# CONVAIR

## COMMERCIAL CHANGE PROPOSAL

SPEC NO.: ZD- 30-005

MODEL: 30-5 (Convair "600")

Page 7A, Center of Gravity Limits:

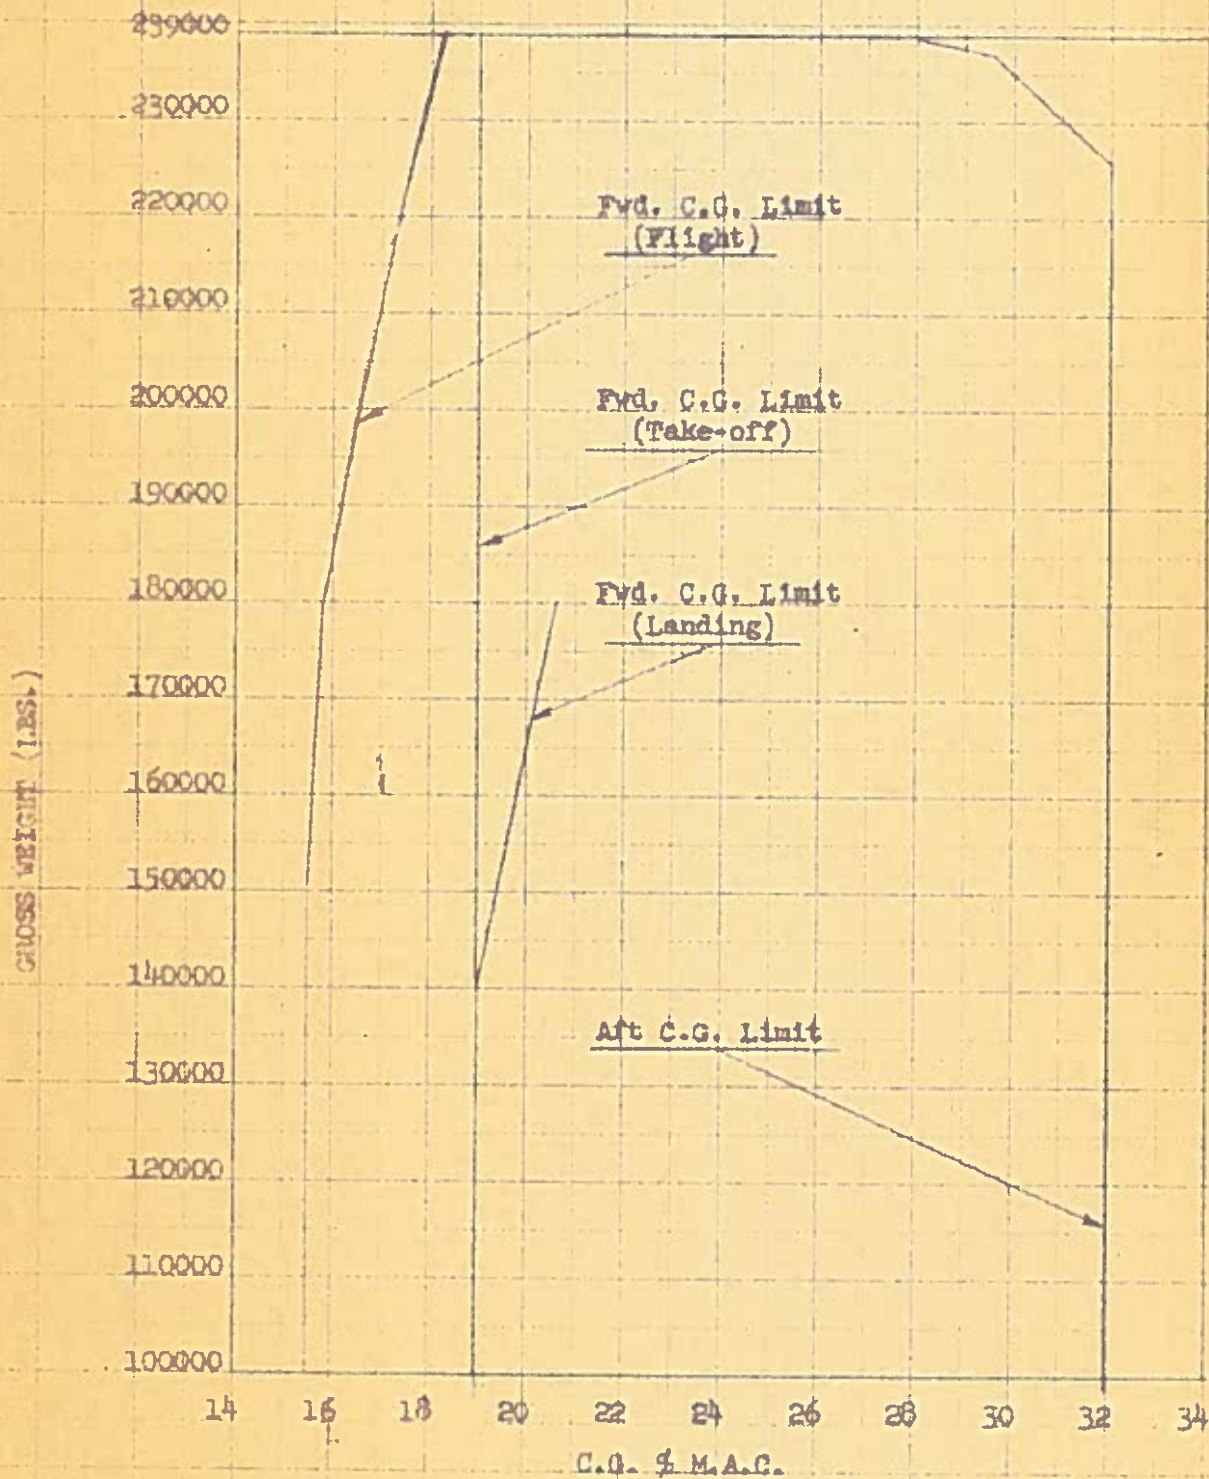
"This proposal has no effect on the specification language but  
revises the C. G. Limits Chart as shown on the attached illustration."

Enclosure: (A) One copy of Convair Sketch - CONVAIR 600 PASS. SEAT -  
ADJUSTABLE FOOD TRAY AND FOOTREST (For information only).

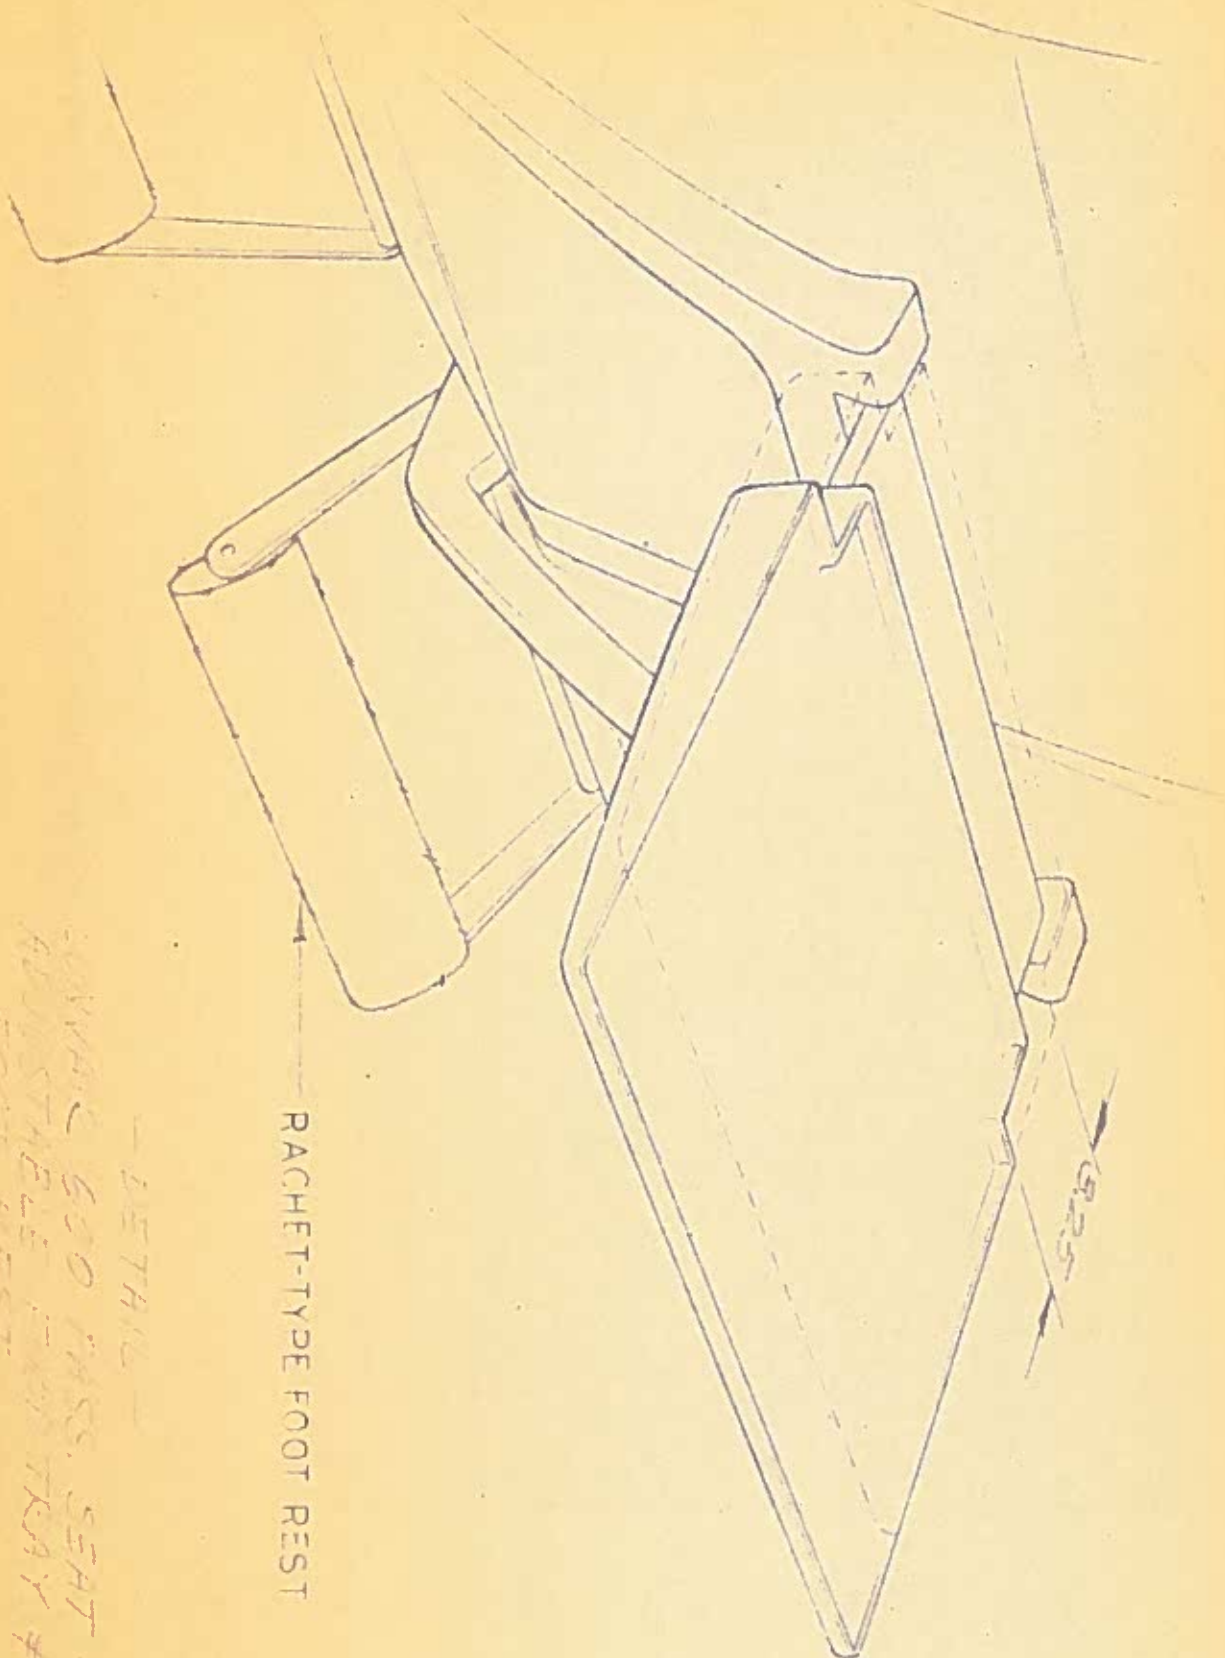
From: "Each passenger seat shall be equipped with a footrest."

To: "A standard and a wide ratchet-type footrest shall be attached to each double seat except the last seat row, the seat row forward of the movable coat dividers and the aft facing double seat."

Enclosure: (A) One copy of diagram warning horn, landing gear control and landing gear position systems (for information only)

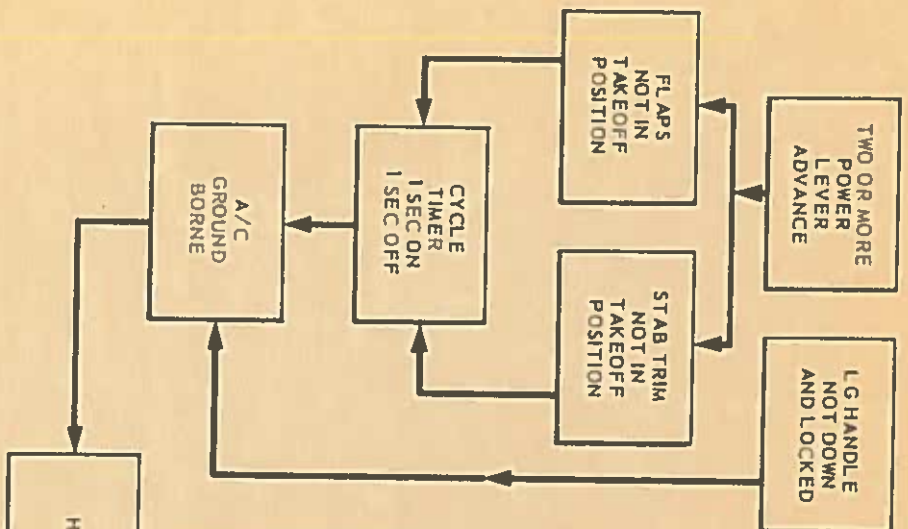
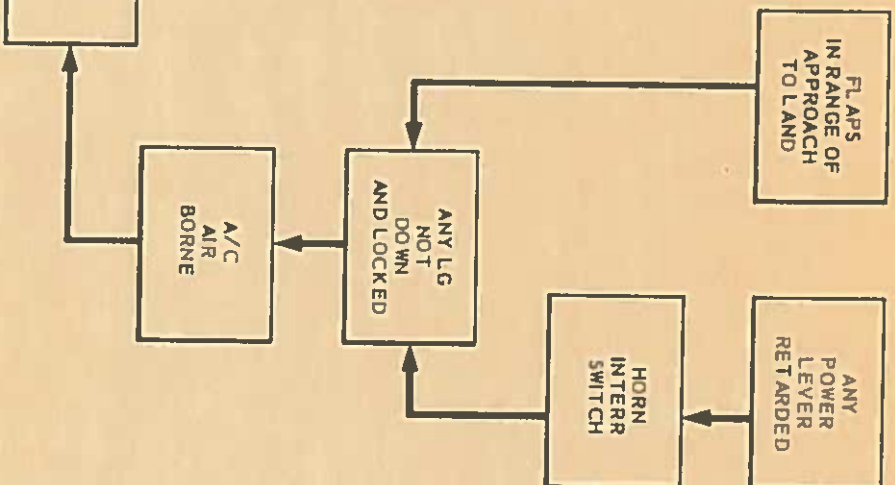
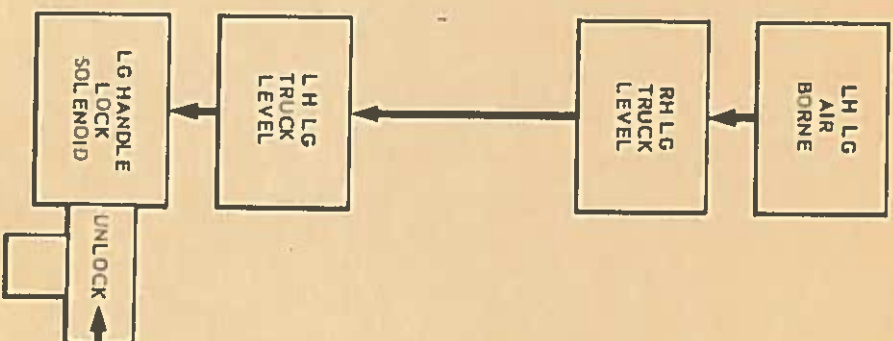
Reason for Change; To clarify that the landing gear control is a function of oleo extension and truck position rather than throttle switches.

Revise the fourth sentence to read as follows:

A diagram of warning horn, landing gear control and landing gear position systems shall be provided at the next revision of the detail specification.

INFORMATION SKETCH  
CONVAIR 600 52" SEAT  
FOR A.A.L. CCP, No 31A

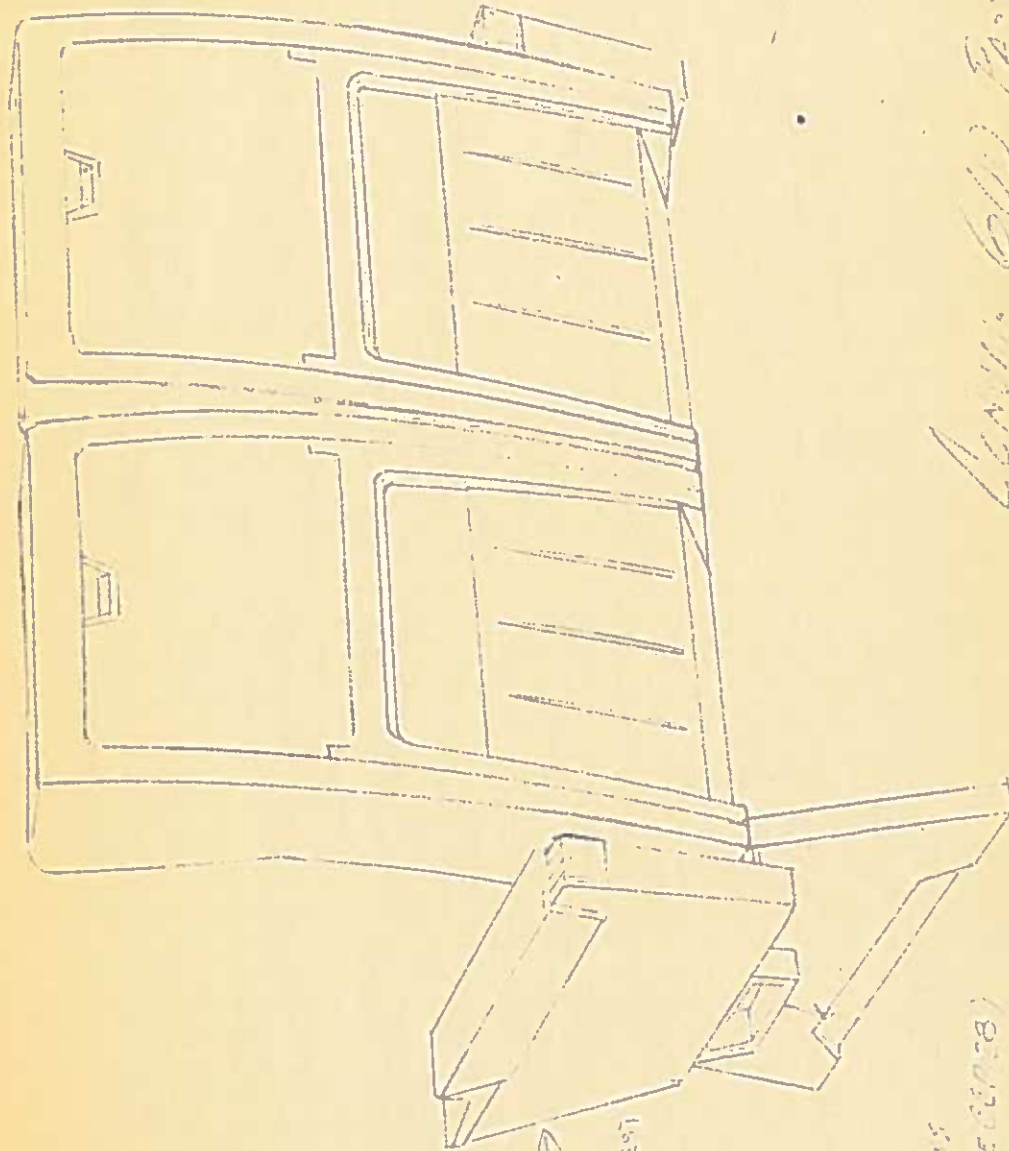
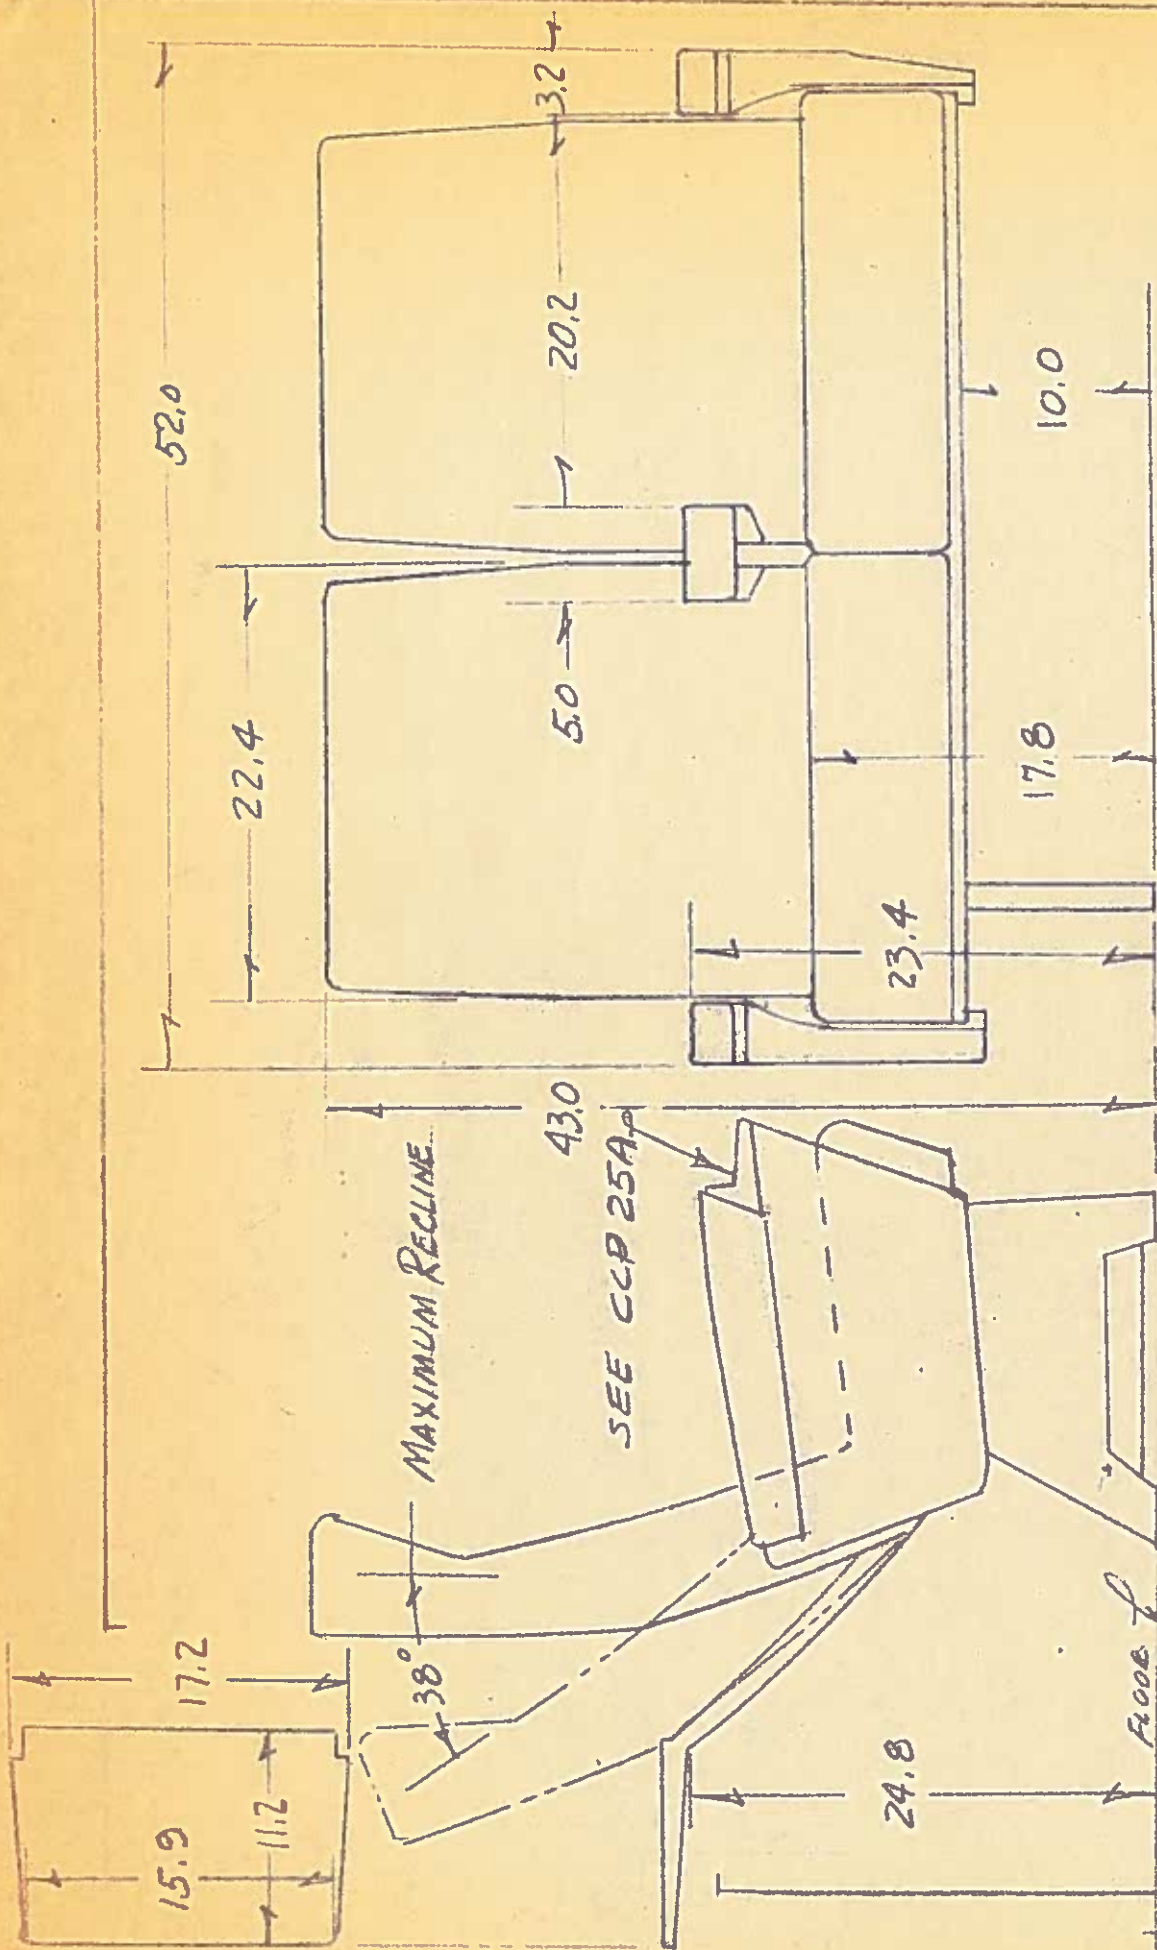
To: "82 Trays, Integral Folding (for 52-Inch Seat) 315.7"

Enclosure: (A) One copy of Convair Sketch "Convair 52 Inch Seat".  
(For information only.)

Enclosure: (A) One copy of Convair Sketch "Convair Passenger Seat" showing installation of stewardess step. (For information only.)

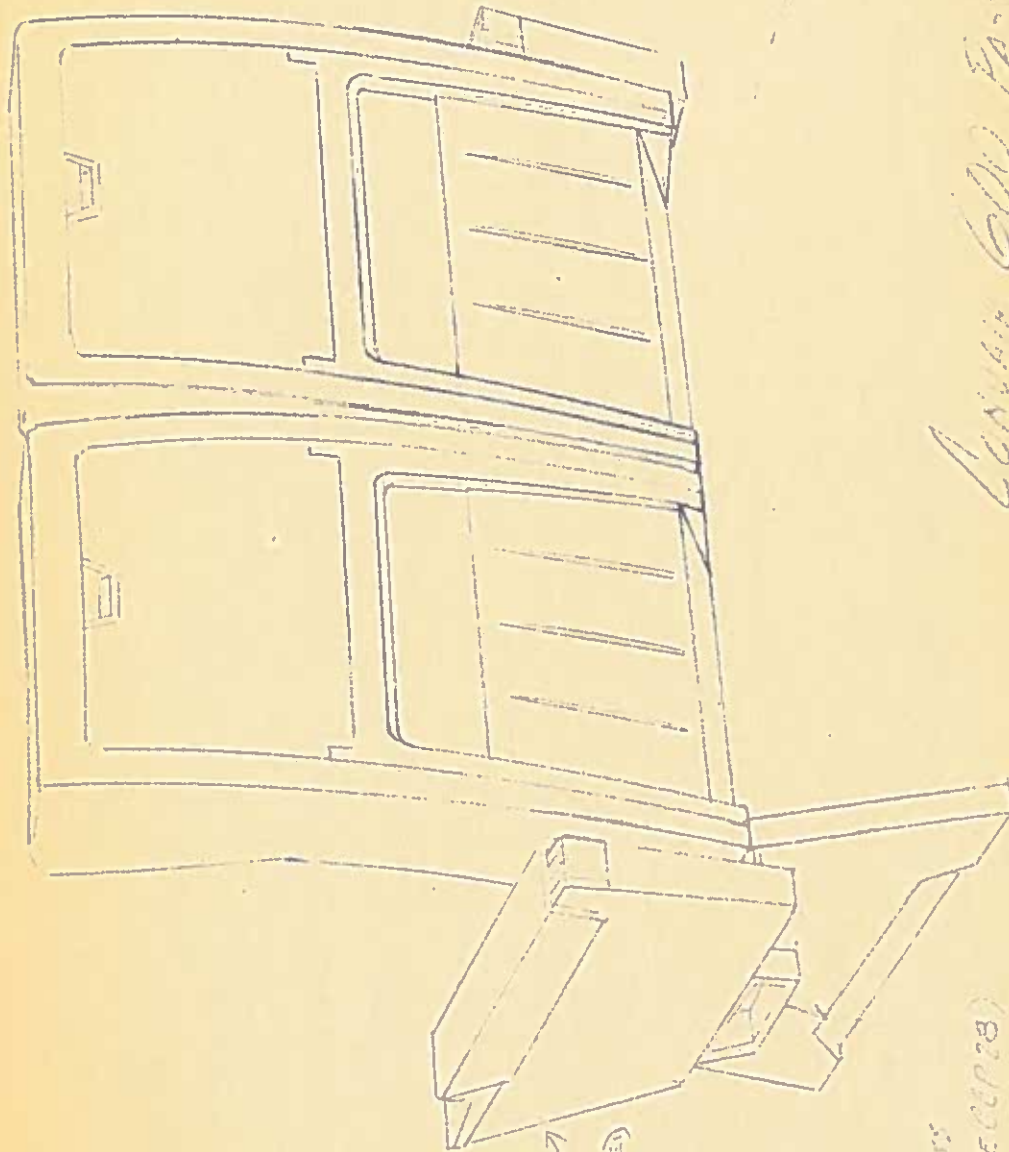
"A stewardess step, including a removable one piece extruded section with back-up structure built into the inboard arm rest, shall be installed. One on each inboard seat in the main passenger compartment for the first class configuration; 25 on the left side and 21 on the right side.

Enclosure: (A) One copy of Convair Sketch - CONVAIR 600 PASS. SEAT  
(For information only.)

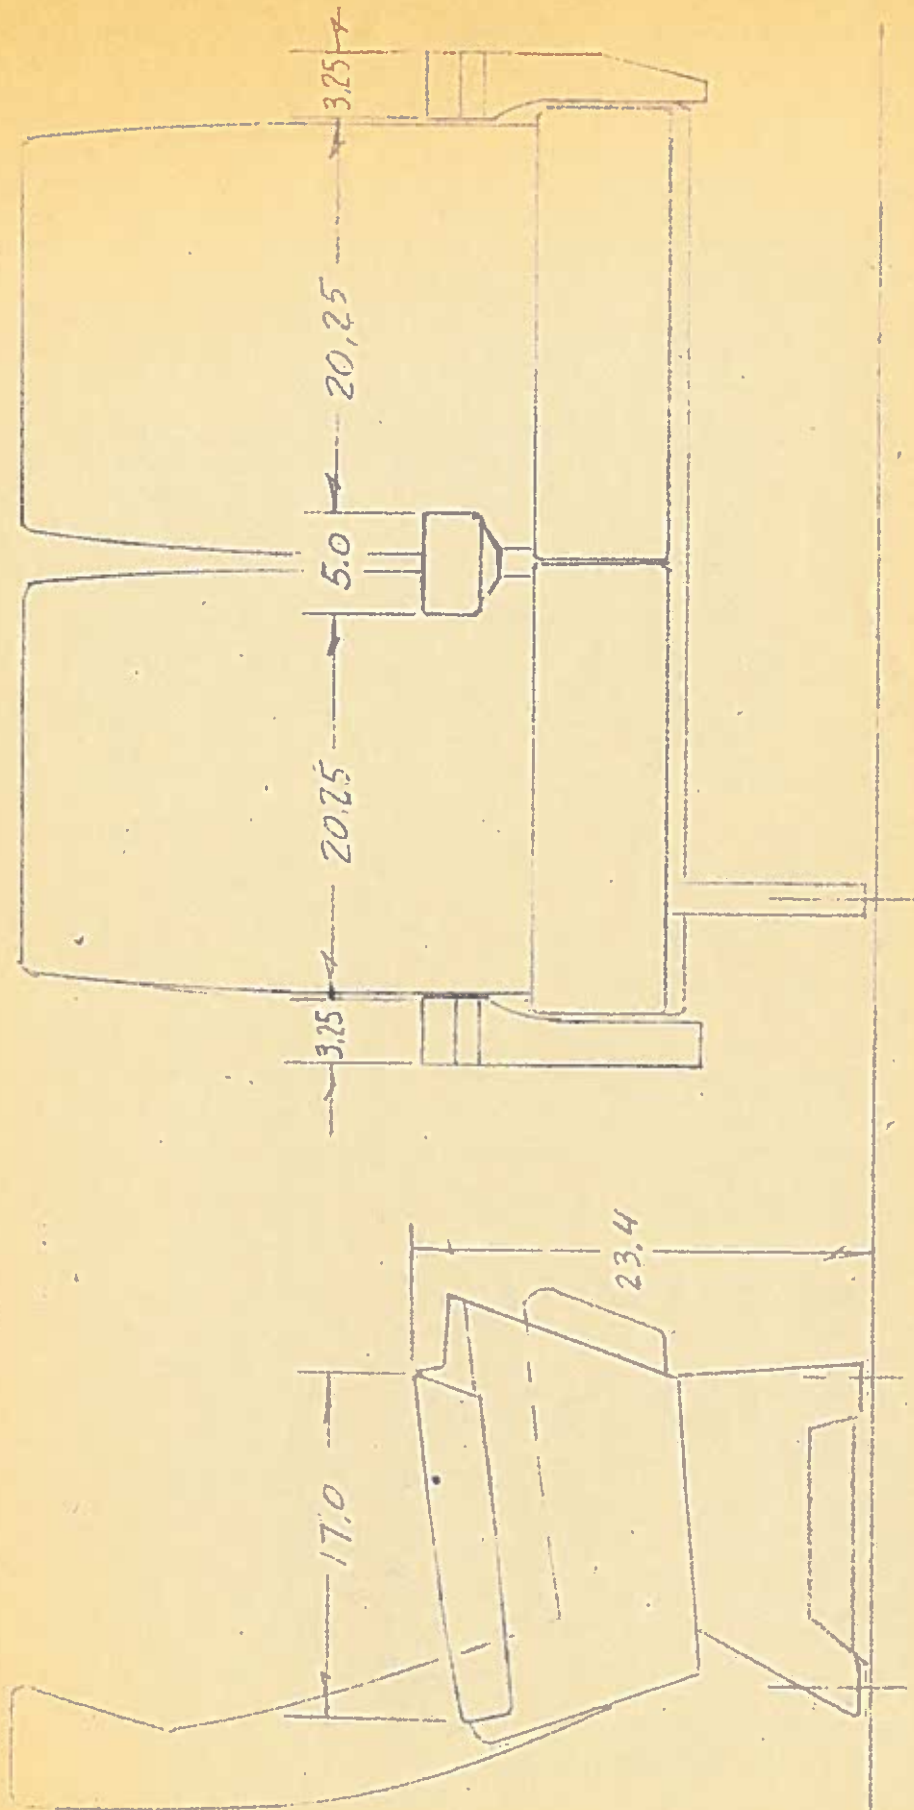
- a. Revises standard outside arm rests for minimum change to accomplish the relocated ash tray and provide wide arm bases.
- b. Redesigns plug-in receptacles.
- c. Revises recline lock handle.
- d. Increase length of arm rest.
